SECTION 009111.13 - ADDENDUM NUMBER 3

- 1.1 **DATE: DECEMBER 17 2024**
- 1.2 **PROJECT: FULTON CO. PUBLIC LIBRARY: ADDITION, RENOVATIONS & SITE IMPROVEMENTS TO: AUBBEE, FULTON & ROCHESTER LIBRARIES**
- 1.3 **PROJECT NUMBER: 24029**
- 1.4 **OWNER: FULTON COUNTY PUBLIC LIBRARY, 320 W. 7TH STREET, ROCHESTER, IN 46975**
- 1.5 **ARCHITECT: ODLE MCGUIRE SHOOK MATTHEW R. MAYOL #IN19900090**

- A. AUBBEE BRANCH: C2.0, C3.1, C7.0 AND C7.1
 - B. FULTON BRANCH: C1.0, C7.0, C7.1 AND L100
 - C. ROCHESTER LIBRARY: C0.0, C1.0, C2.0, C3.0, C3.1, C7.0, DA102, A102, A103, A105, A401, A202, A203, A501.

C3.1
 PROPOSED DRAINAGE PLAN

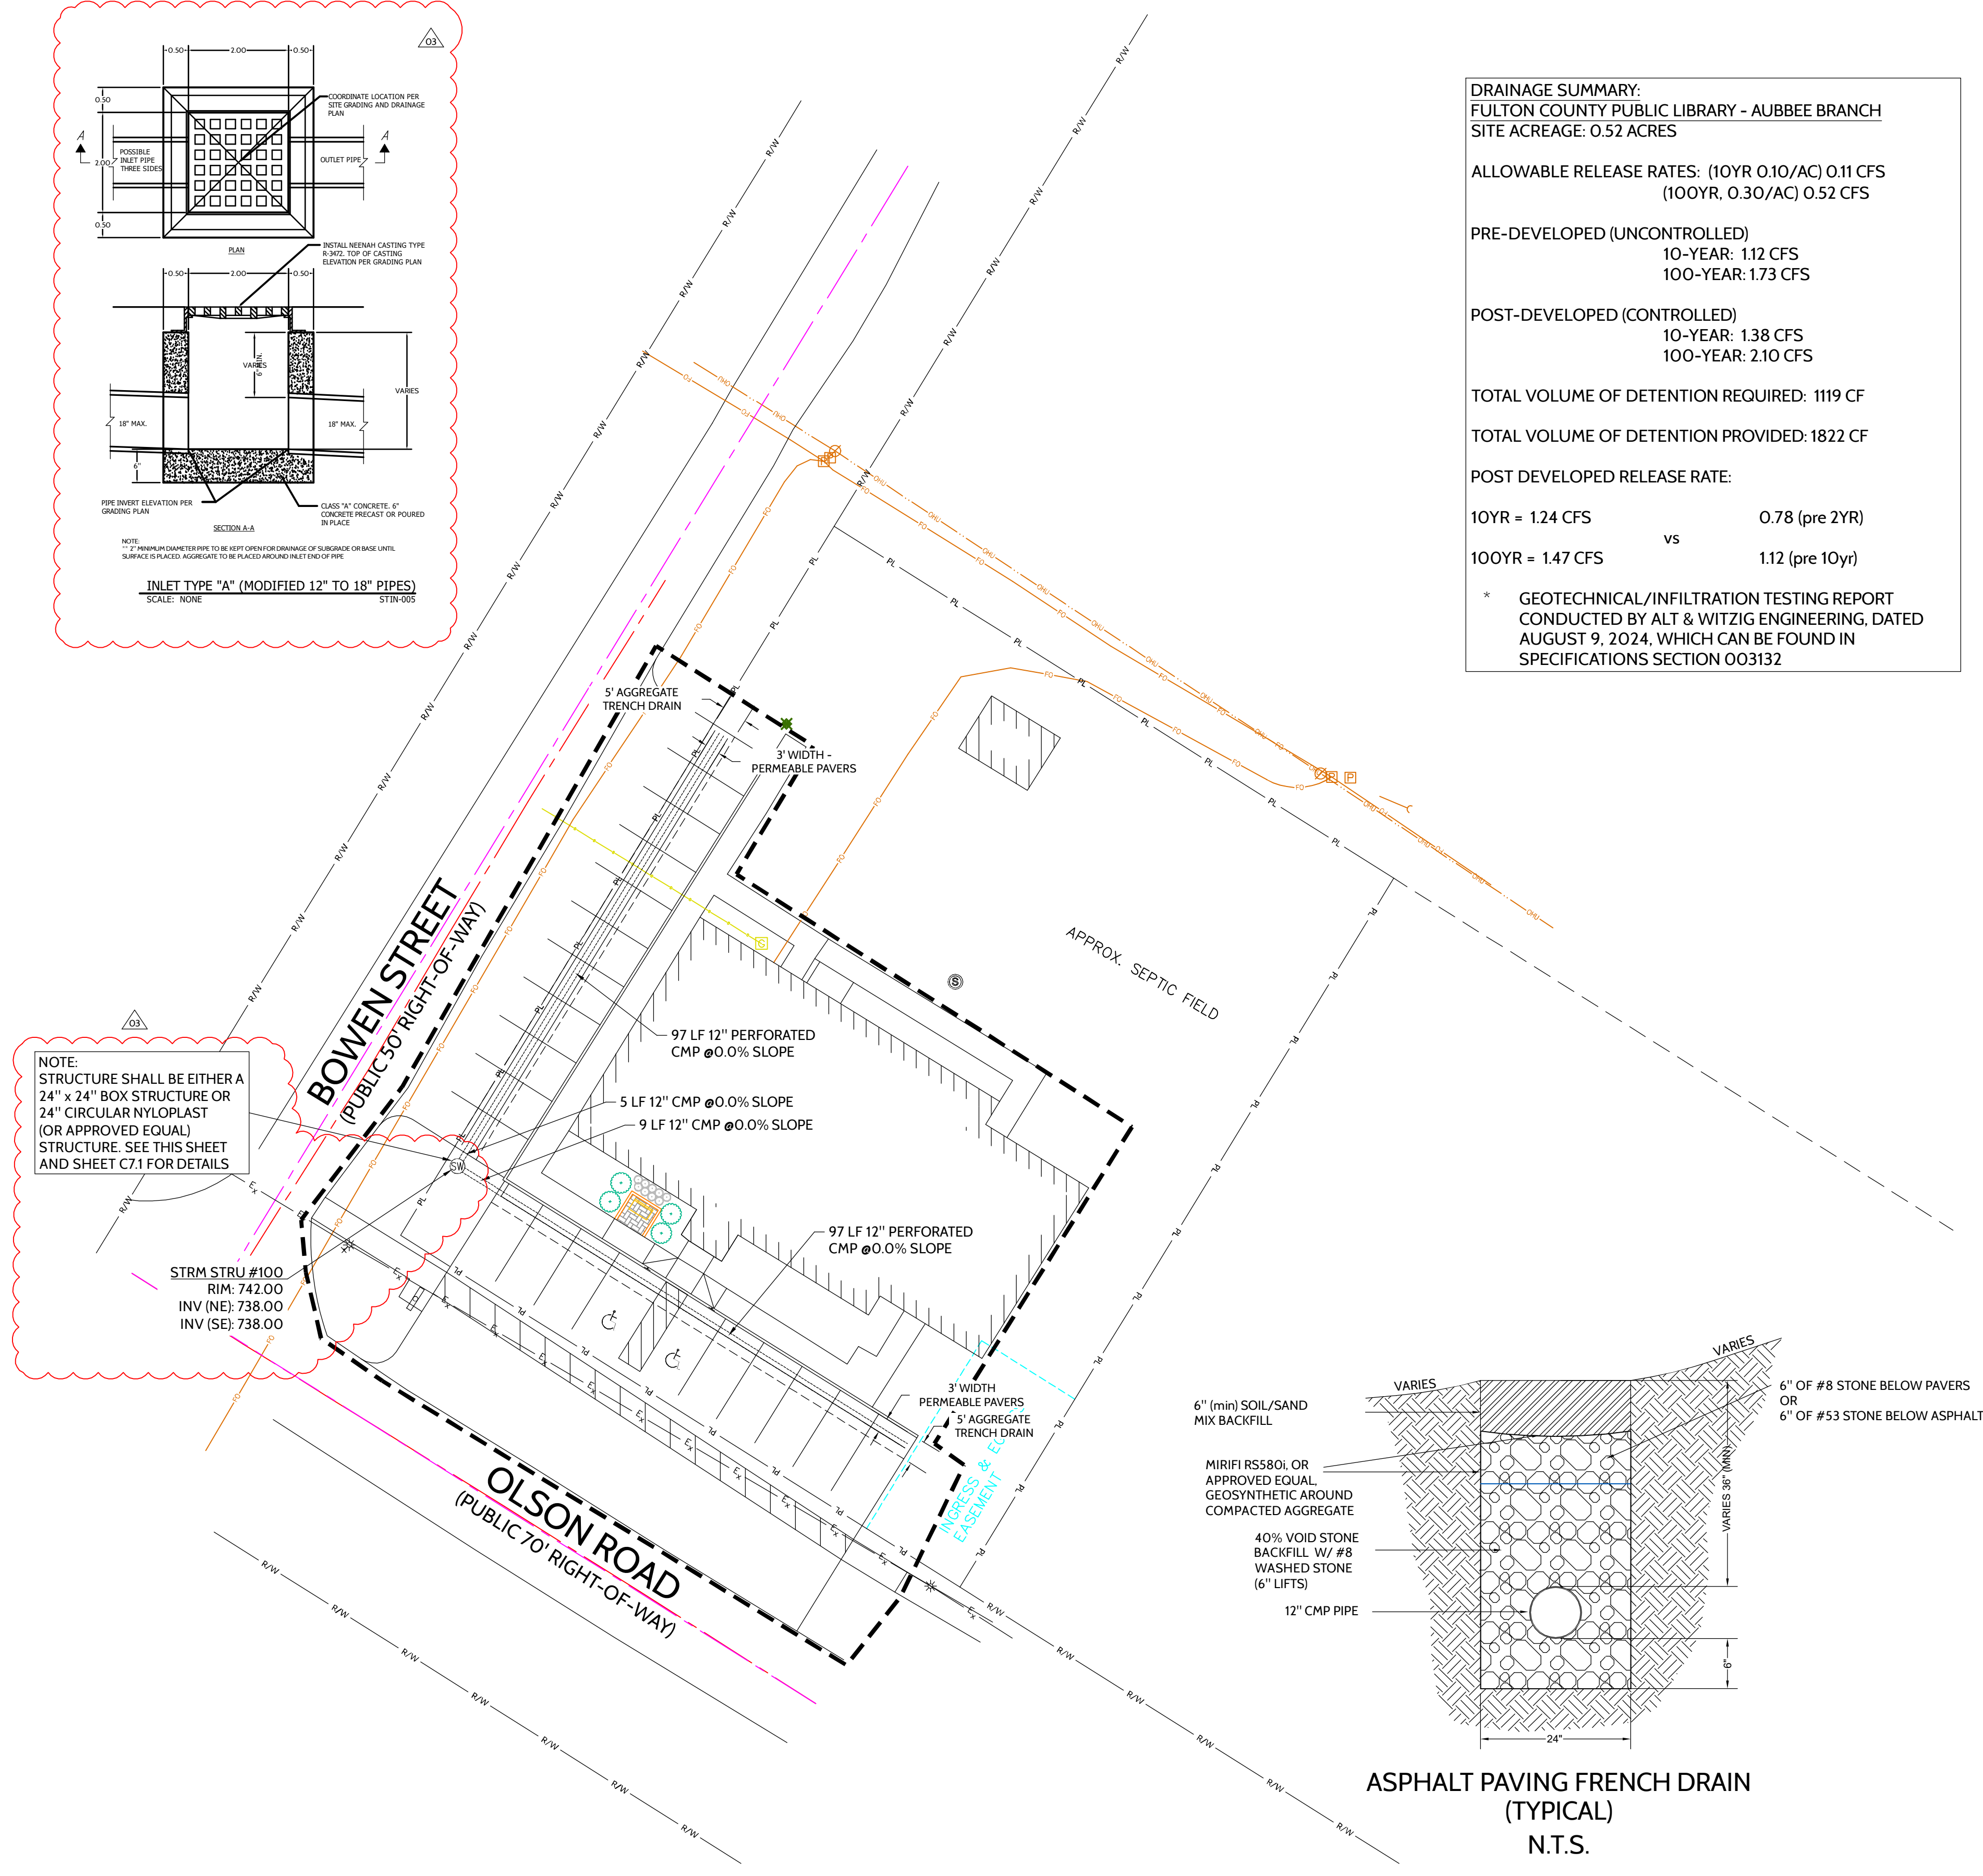
2. Q: (Aubbee) Can we use perforated ADS N-12 in lieu of the perforated CMP that is called out on plan sheet C3.1?

8. Q: (Aubbee) Storm drainage plan shows width and LF specifications but no pipe inverts or specified depths for installation of trench drain. Would you please provide inverts and depths of excavation for storm piping?

- a. A: After reviewing the drainage and specifications for ADS N-12, and it's application in this project's use, the engineer agrees that N-12 can be substituted for CMP.

- a. A: Please see the revised sheet C3.1.
9. Q: (Aubbee) There is not a detail included in the drawings for the barrier curb called out on C2.0. Please provide this detail.

FULTON BRANCH
PLANTING PLAN &
PLANT DETAILS

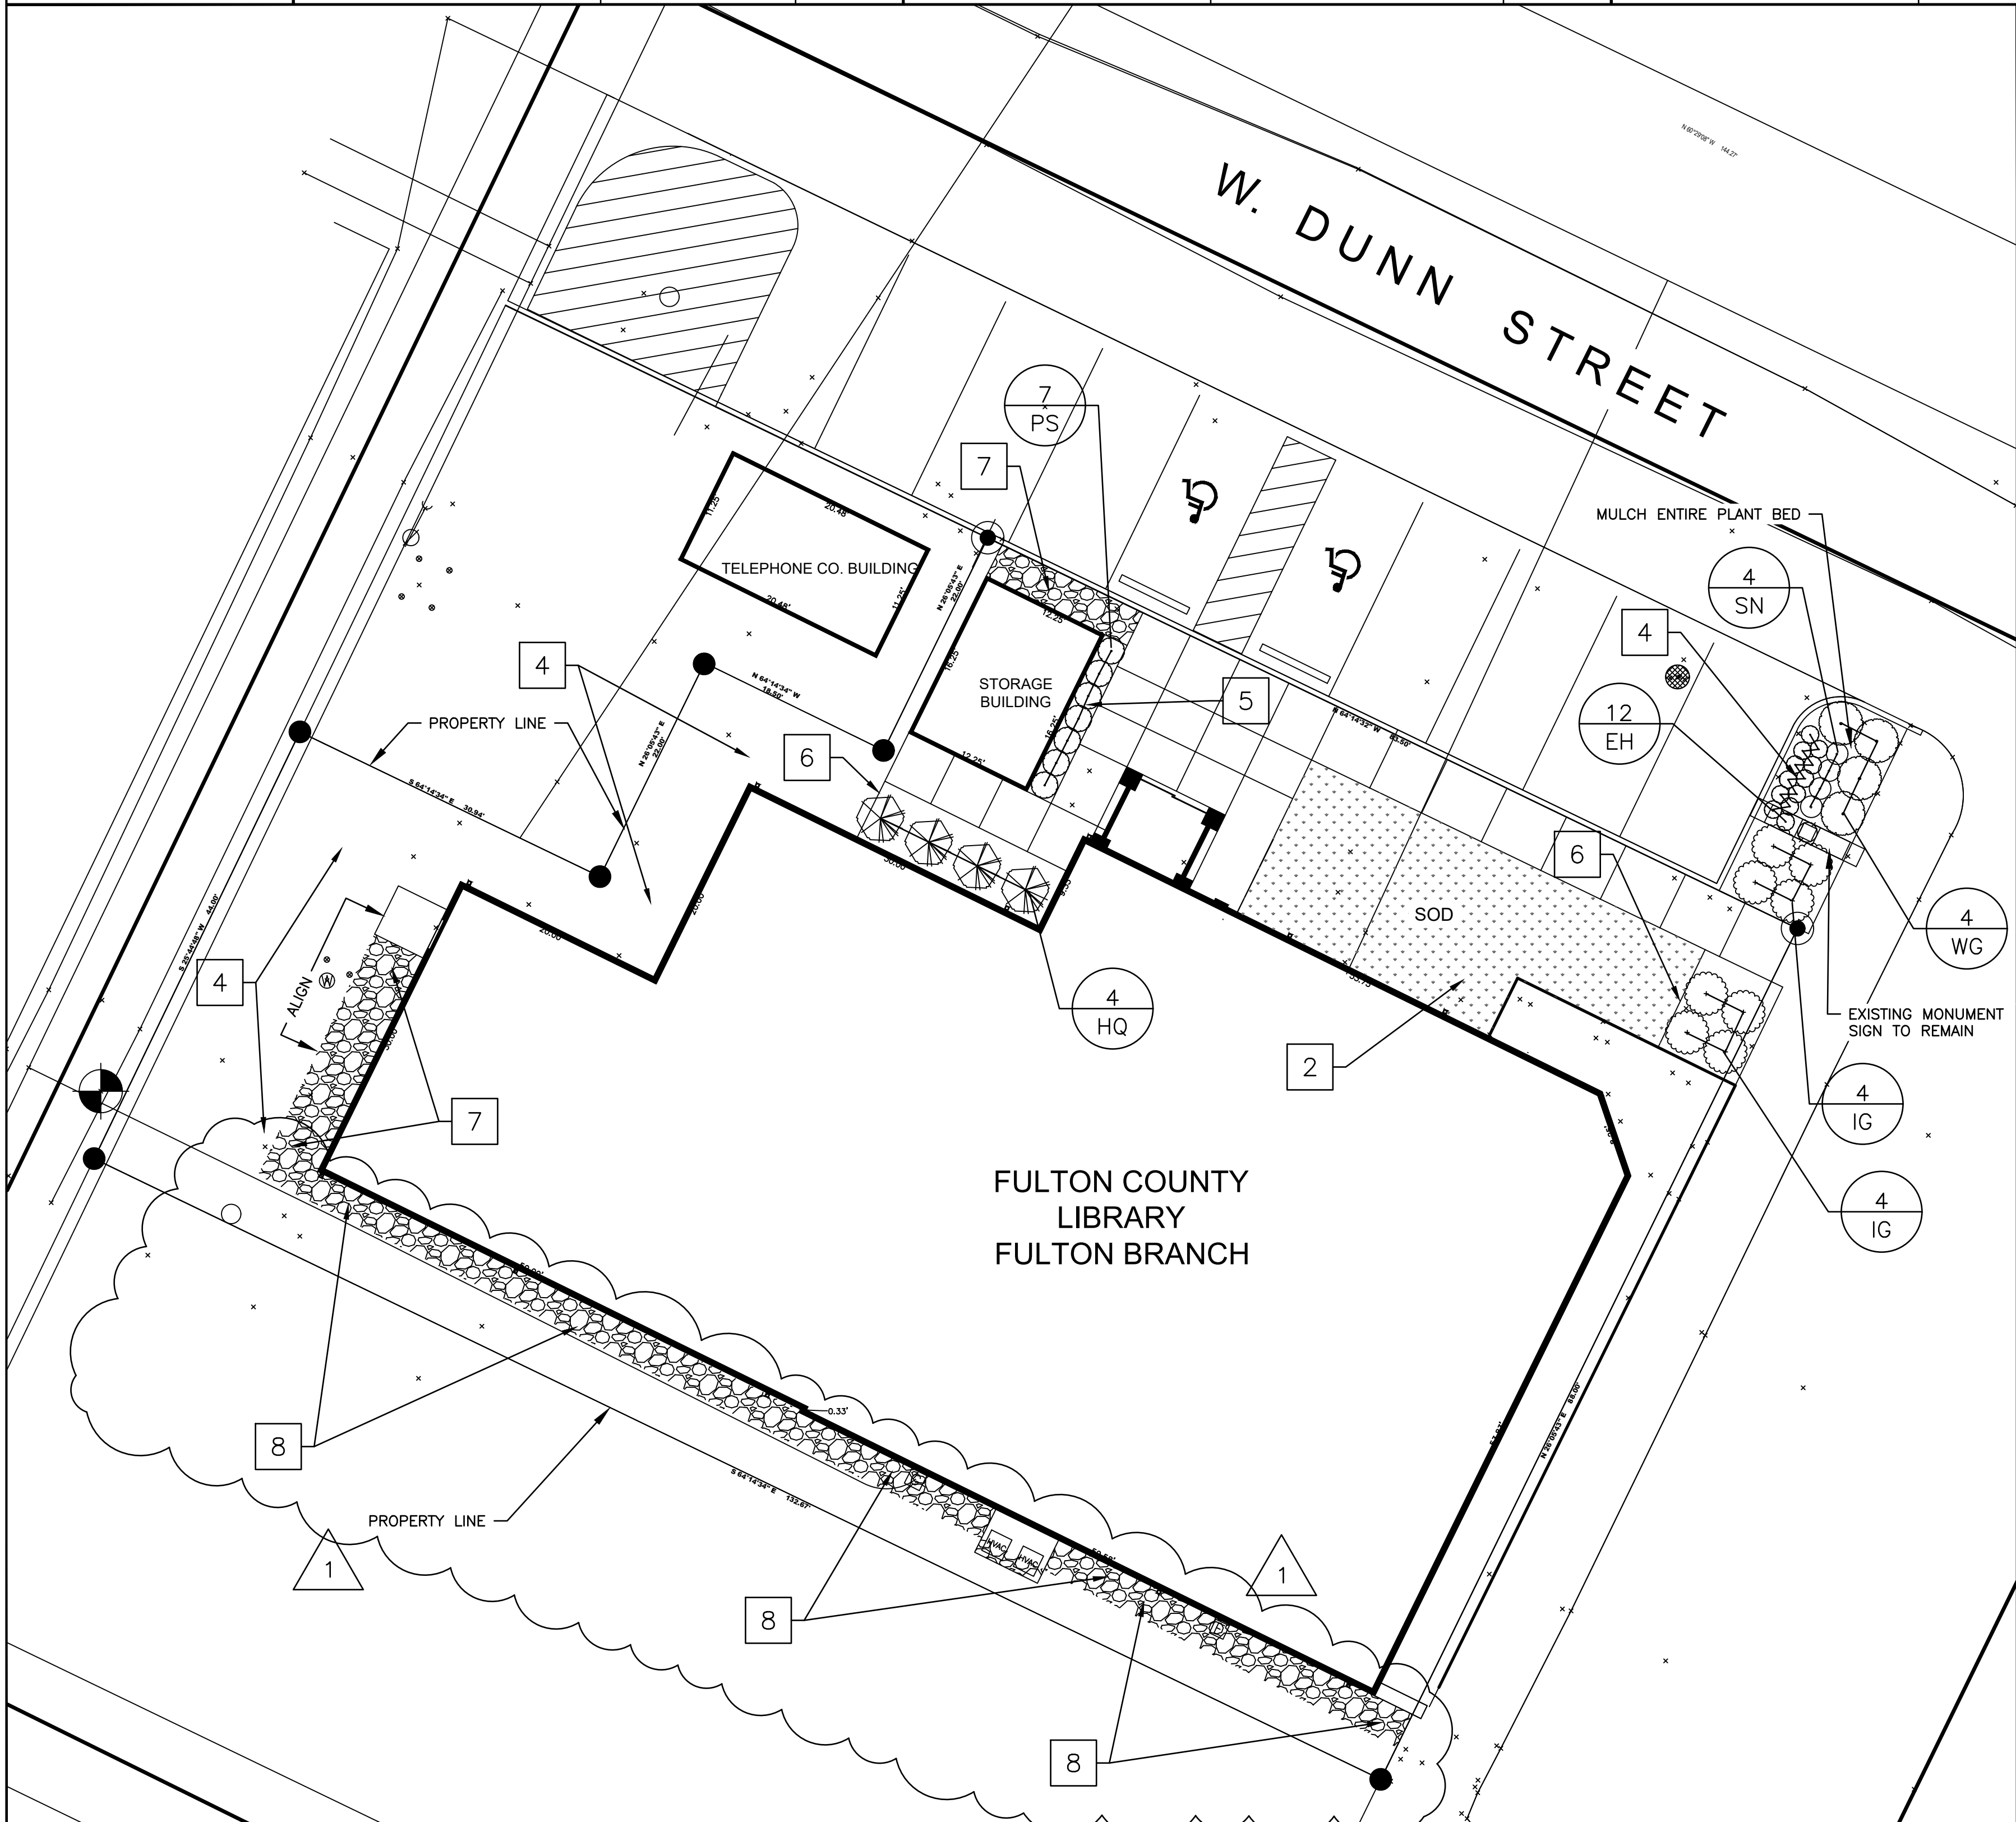
- A. On L100 Refer to Revision Triangles:
 1. Add Landscape Note 8 regarding limits of mulch on southwest side of building per attached Drawing L100
 2. Revise limits of landscape mulch on southwest side of building per attached Drawing L100
